OFFICIAL COORDINATION REQUEST FOR NON-ROUTINE OPERATIONS AND MAINTENANCE

COORDINATION TITLE- 16JDA01

PROJECT- JDA

Figure 1: Diagram (left, closed position) and photograph (right, open position) of the wing gates within the JD-S CC.

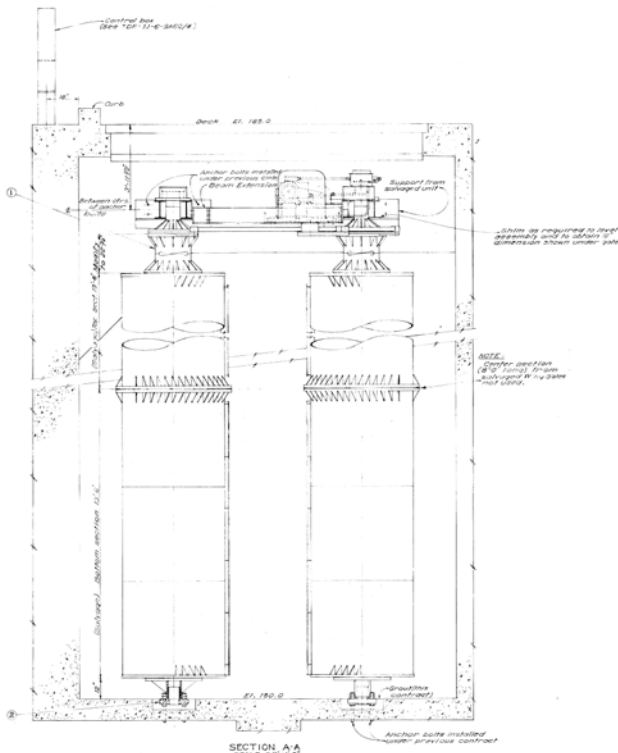
1. Remove Wing Gates: Two wing gates currently sit in the John Day Dam South (JD-S) fishway collection channel (figures 1 and 2) at turbine bay 9. They were constructed with the dam in 1964 in order to facilitate a partial closure or restriction of the collection channel (CC) in an emergency situation. However, they have never been used and due to the reduction in the number of floating orifice gates (FOGs) in 2005 (from ten to four), they are currently obsolete. According to the 2004 Hydraulic Evaluation of Lower Columbia River Adult Bypass Systems (HELCRABS) report, the wing gates actually impede hydraulic conditions (flows) within the CC during regular operations, and the report recommended their removal in order to improve hydraulic conditions and fish passage (Recommended Structural Improvements, page viii).
